Starboard Drive Definitive Subdivision

DS 2022-01 Starboard Drive Definitive Subdivision

Stormwater Peer Review:

BBC/TNC/NHESP BioMap2 Coastal Adaptation Analysis

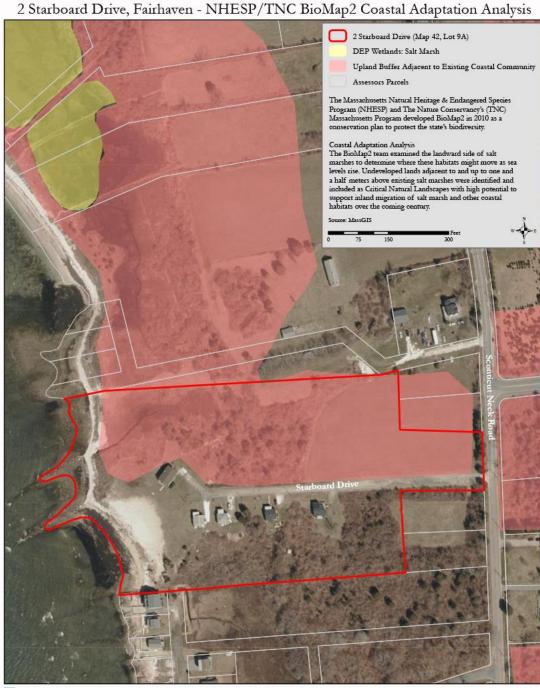
- The conservation agent attached a map created by the Buzzards Bay National Estuary Program showing areas that are likely to be critical for salt marsh migration to adapt to sea level rise. The yellow is DEP mapped salt marsh and the red are the areas that may be crucial to supporting coastal resiliency and salt marsh migration.
